**Harker Heights  
Planning and Zoning  
Commission  
Meeting & Workshop**

## PLANNING AND ZONING COMMISSION MEMORANDUM

1. Motion to **approve, approve with conditions, or disapprove with explanation** a request for Preliminary Plat for the subdivision referred to as The Enclave at Indian Trail, on property described as a 16.92 acre tract of land situated in the W. E. Hall Survey, Abstract No. 1086, and the J. M. Roberts Survey, Abstract No. 3, and being all of the called 2.980 acre tract of land described in a deed to Terra Azul Developments, LLC., recorded in Instrument No. 201300048431, Deed Records of Bell County, Texas, all of the called 7.971 acre tract of land described in a deed to Terra Azul Developments, LLC., recorded in Instrument No. 201300048422, Deed Records of Bell County, Texas, all of the "Parcel 1" called 3.003 acre tract of land described in a deed to Terra Azul Developments, LLC., recorded in Instrument No. 201300048429, Deed Records of Bell County, Texas, all of the "Parcel 2" called 2.649 acre tract of land described in a deed to Terra Azul Developments, LLC., recorded in Instrument No. 201300048429, Deed Records of Bell County, Texas, and a part of Lot 1,

**PRELIMINARY PLAT FOR:**  
**THE ENCLAVE AT INDIAN TRAIL**  
CITY OF HARKER HEIGHTS, BELL COUNTY, TEXAS

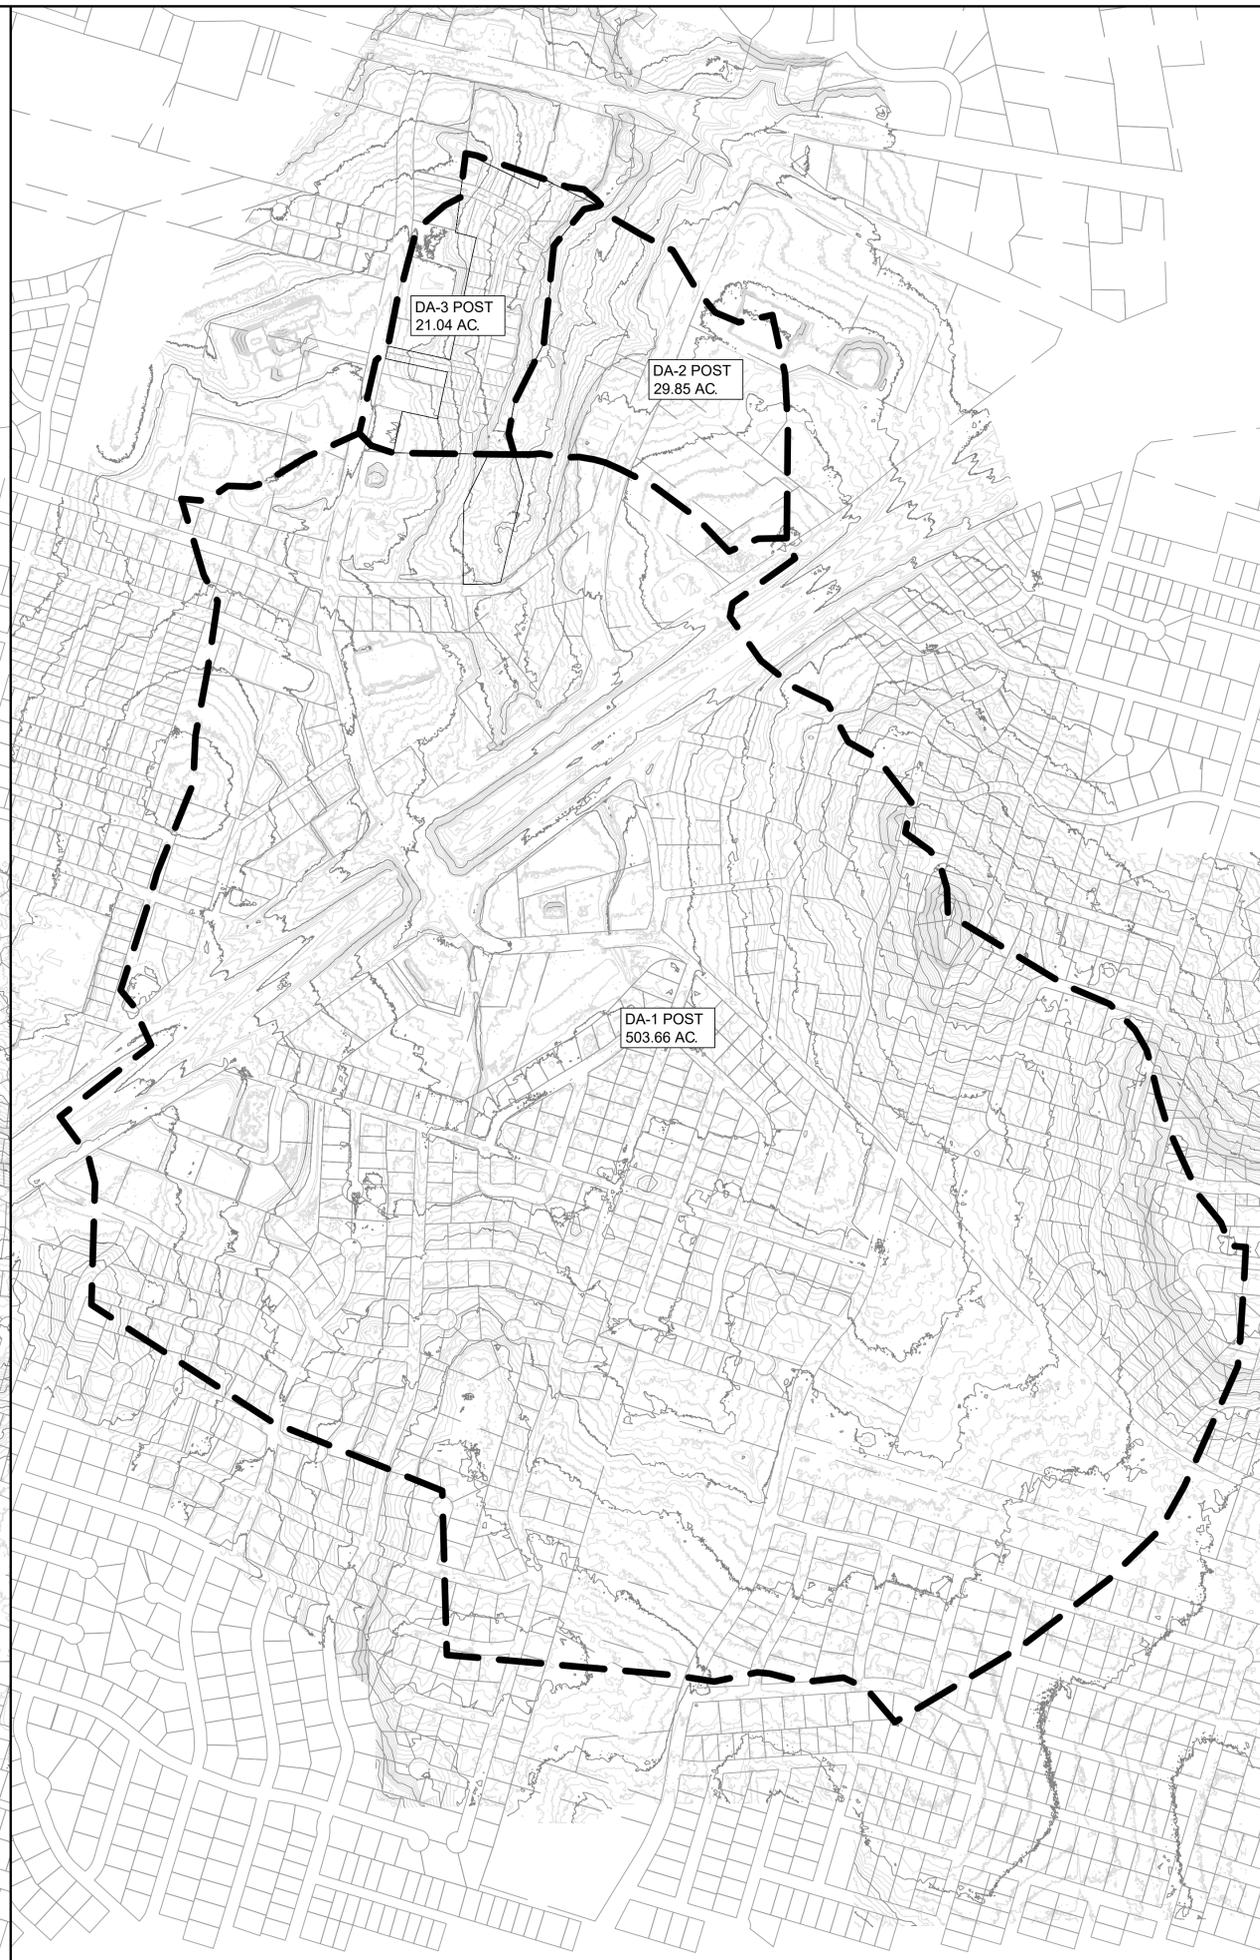
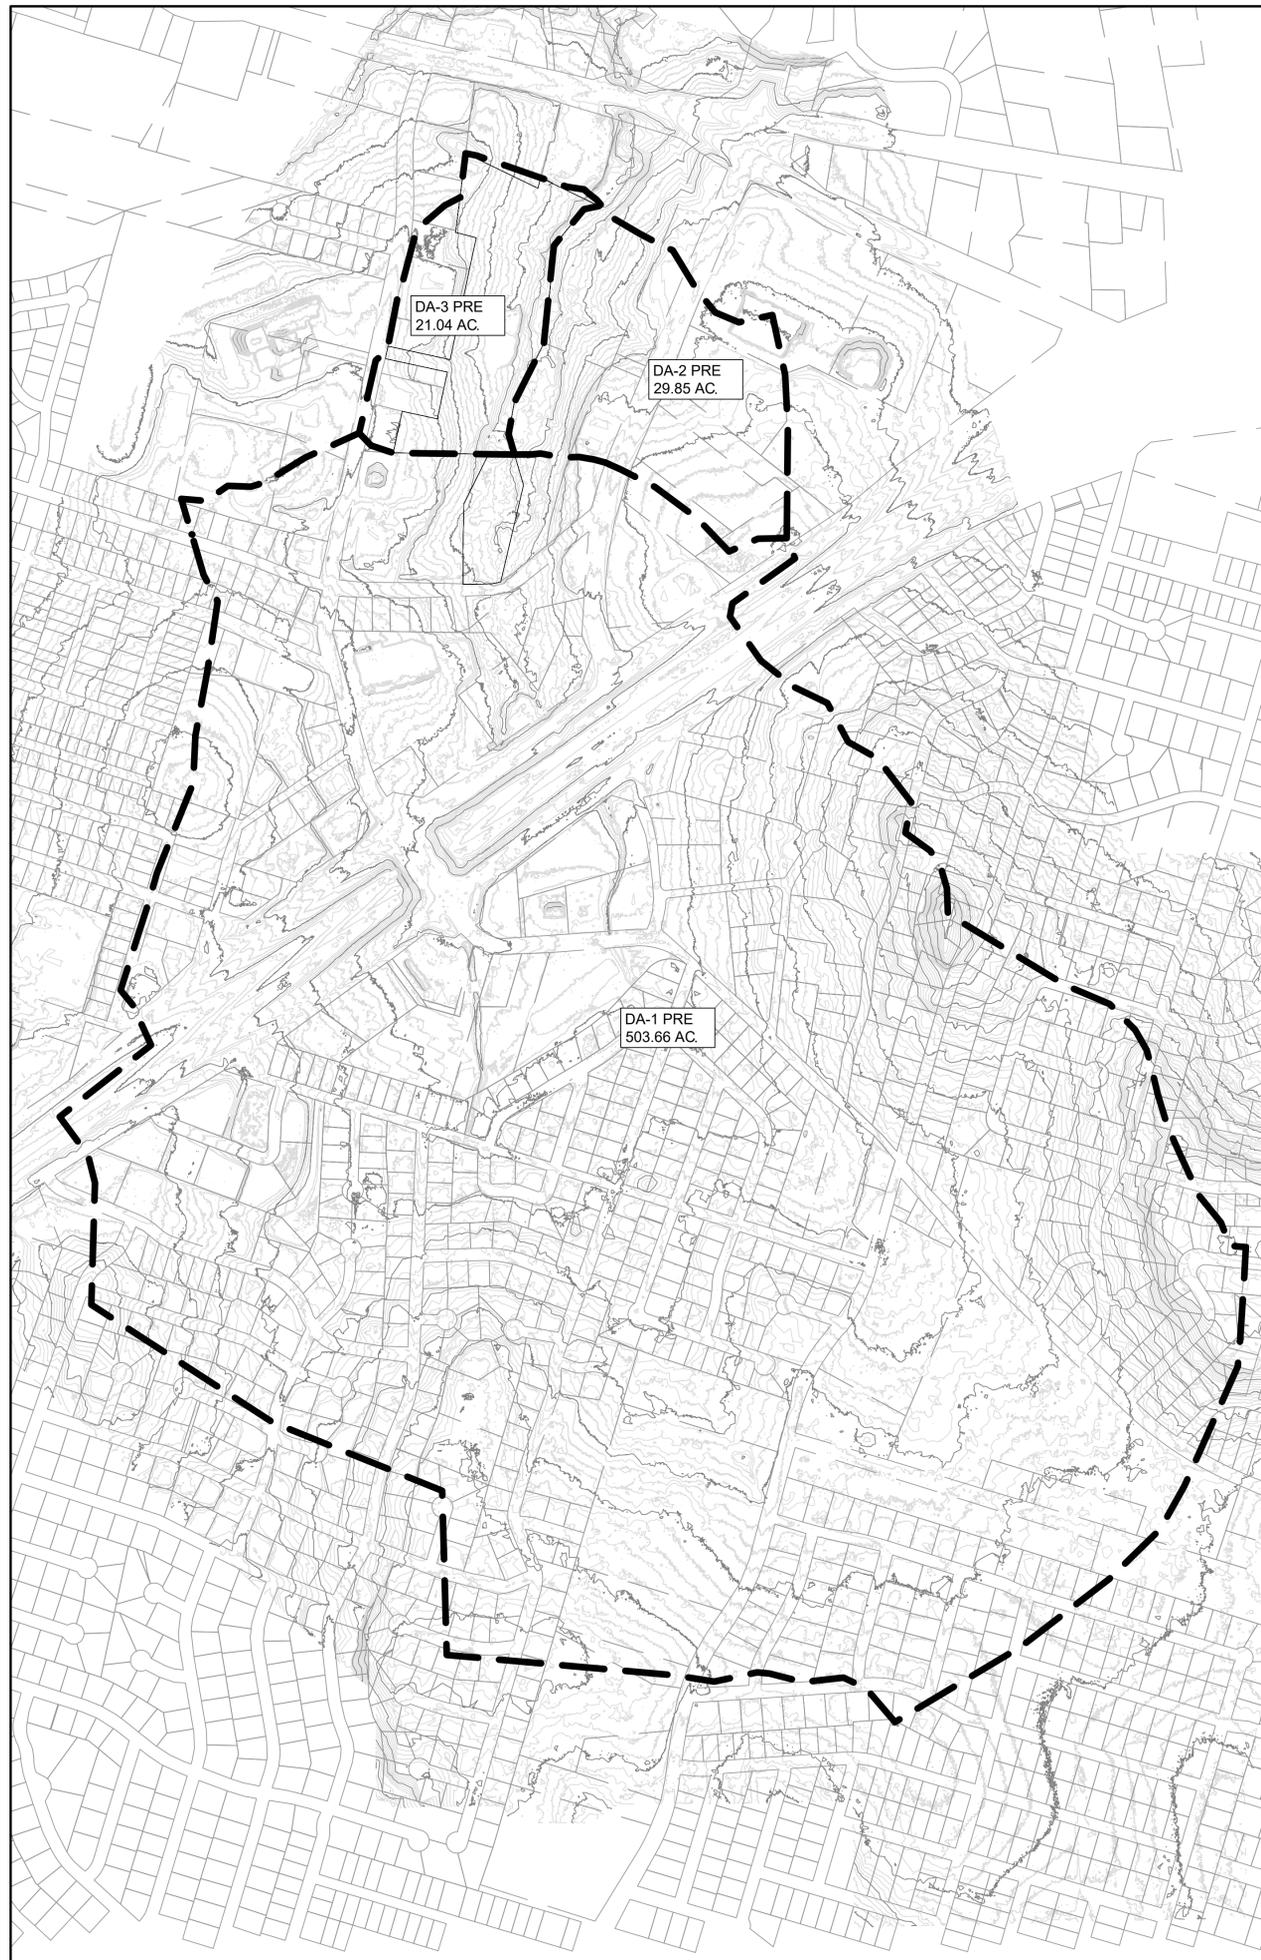
5. Plat Dedication Page: Applicant shall add a note indicating that on this plat dedication page Tract 2 is composed of Drainage Tracts A-E as referenced in Ordinance 2021-19 and that Tract 1 is composed of Tract F as referenced in Ordinance 2021-19.

7. Plat Dedication Page: Applicant shall add a note indicating that Lot 1 as referenced in Ordinance 2021-19, is not part of this plat.

11. Plat Dedication Page: Applicant shall provide annotations (distance into the Lot from corner of lot) for the variable width drainage easement in Lot 20, Block 1 such that it is able to be located in the field.

12. Plat Dedication Page: Applicant shall clarify why the variable width drainage easement shown in Lot 20, Block 1 is not part of Tract 2.

16. Plat Dedication Page: Applicant shall clarify the limits of the called "Drainage Reserve" and annotate the hatched Floodway area.

18. Plat Dedication Page: Applicant shall add a utility easement to Tract 1 illustrating future connectivity to water/sewer and add drainage easements for those portions of Tract 2 that will have drainage infrastructure and are not within the SFHA.

**A Lot Number Change Table has been added to clarify the lot numbers from the proposed plat and Ordinance 2021-19.**

**Note 3.1 was added to the plat to address this comment.**

**The variable width drainage easement has been revised to a 15' D.E. parallel to the rear lot line of lots 20-22, block 1.**

**The variable width drainage easement has been revised to a 15' D.E. parallel to the rear lot line of lots 20-22, block 1. This easement will allow future stormwater passage from Tract 1 and neighboring parcels.**

**Utility and drainage easements have been added for Tract 1, as well as a sewer cleanout for future tie in. The utility easement allows for future water connectivity if needed. Drainage easements have been added to Tract 2 for the proposed storm drain systems.**

**Recording information has been added for the Drainage Reserve.**

SIGNATURE		DATE	
THIS DOCUMENT IS RELEASED FOR THE PURPOSE OF REVIEW UNDER THE AUTHORITY OF JOSEPH THERIOT, P.E. 120299 ON 5/18/2021. IT IS NOT TO BE USED FOR CONSTRUCTION, BIDDING, OR PERMIT PURPOSES.		PM	JAT
DESIGN	JAT	DRAWN	JAT
CHECKED	JAT	PROJECT #	21-020-001
DRAWING #			<b>2</b>

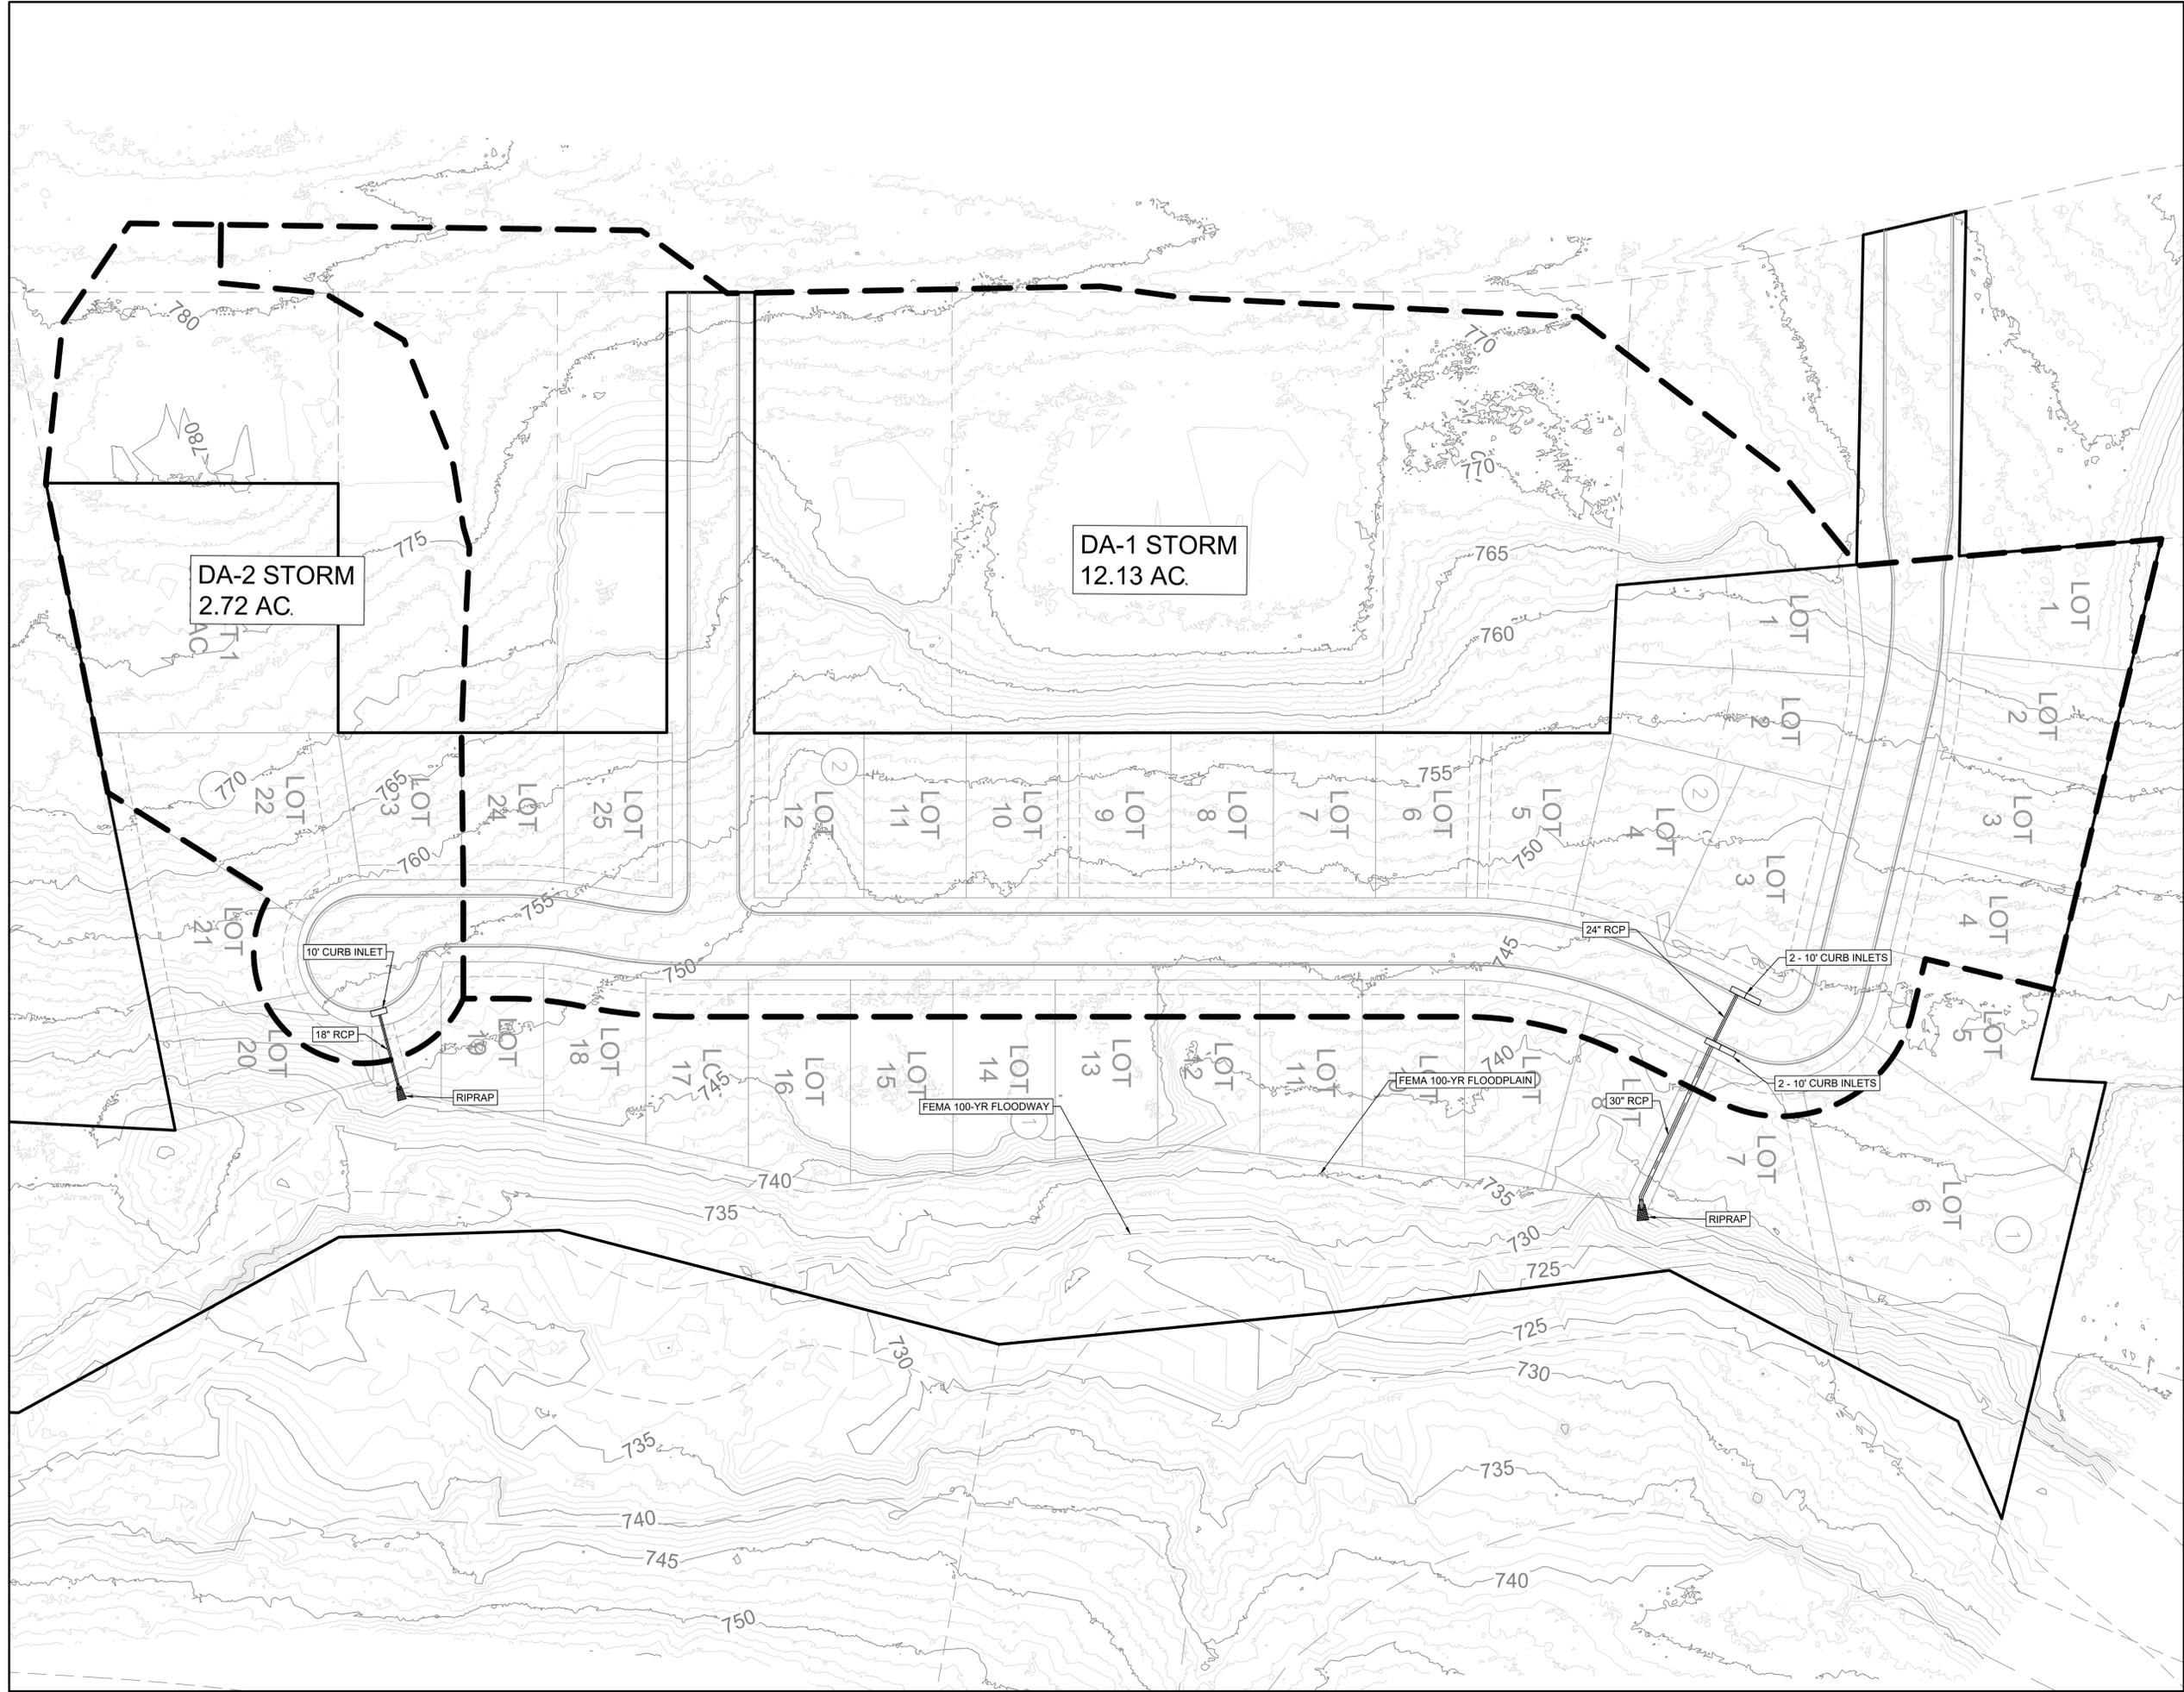
19. Drainage Report: Applicant shall provide pre and post development drainage calculations for Q100. Partially Met. The applicant has annotated two different drainage basins as DA-2 for post development drainage calculations (annotations on Sheets 2 & 3 don't appear to match). Please clarify which calculations in the report corresponded to each illustrated drainage basin. Also clarify/address how the impact of the increase in flows and new point discharge from DA-3 shown in the drainage report will be mitigated (i.e. add a statement regarding energy dissipation and timing of discharge).

**Sheets 2 & 3 both have a "DA-2". Sheet 2 is labeled DA-2 POST while Sheet 3 is labeled DA-2 STORM. The two areas are not meant to represent the same areas. The preliminary drainage report only calculates pre- vs. post-development flows. Internal storm drain calculations will be part of the final drainage report accompanying the construction plan submittal.**
